Subject: Re: Westpoint Harbor

I've attached a pdf file representing the Westpoint Harbor Draft Phase 1 Landscape Concept, dated October 5, 2011 for your review and comment. Please respond as soon as you are able.

REDWOOD CITY, CALIFORNIA

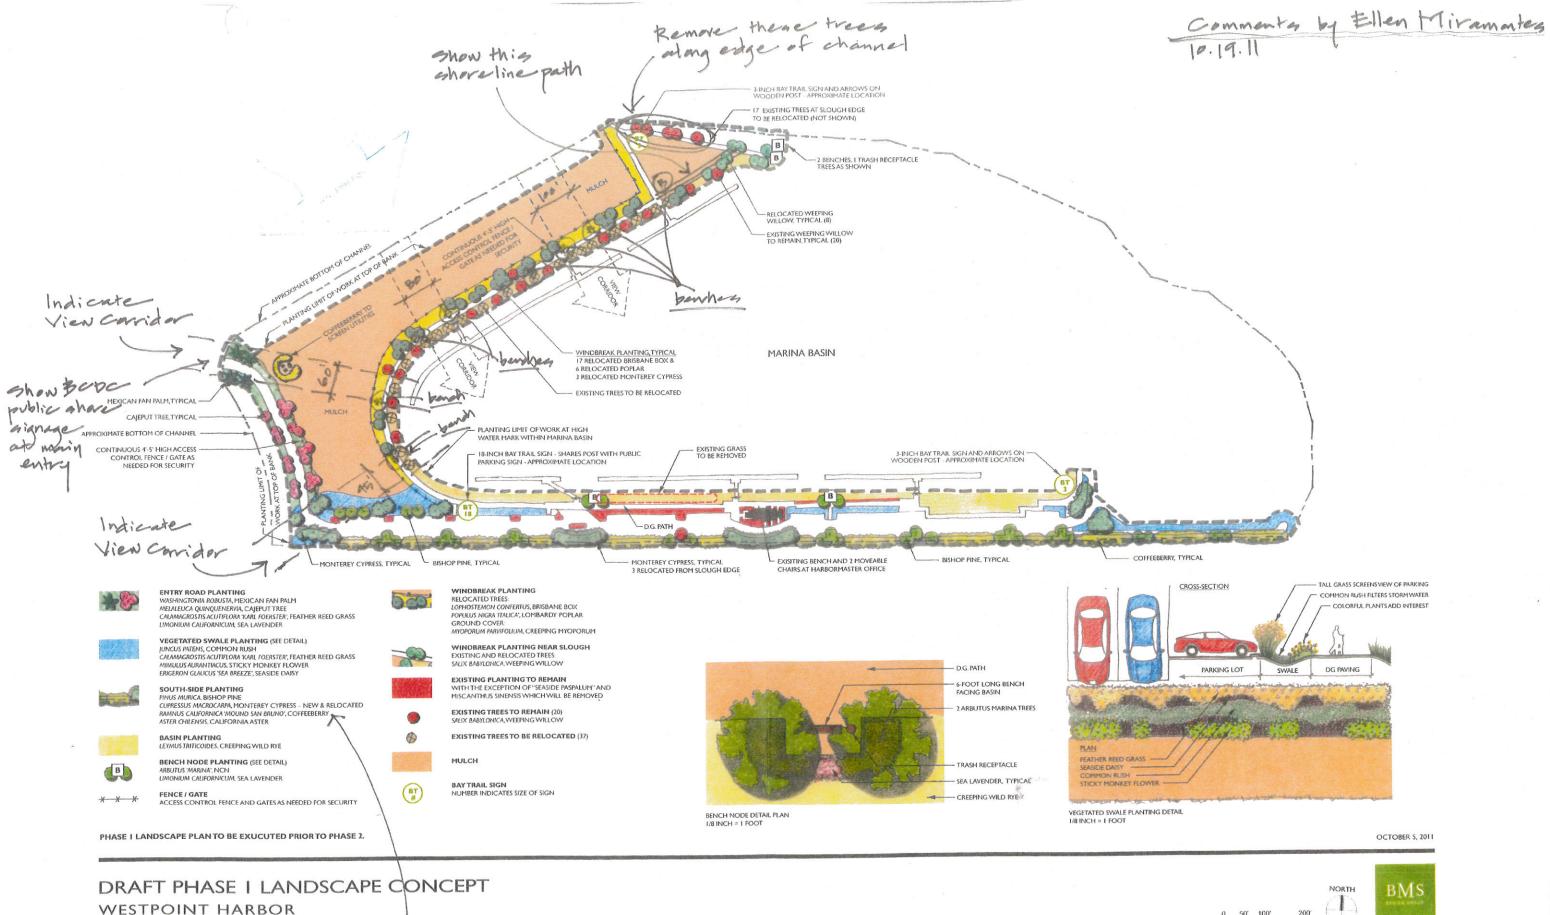
Please find my comments in response to the landscape concept attached. For additional benches, please follow approximately what is shown on the 8/7/06 DRB Planting and Furnishing Plan. For clarity, I think it would be best to provide a separate signage plan.

Recommend adding more chrub types in case coffee; berry does not do well; could mix 2 or 3 chrub types for variety and to ensure viability
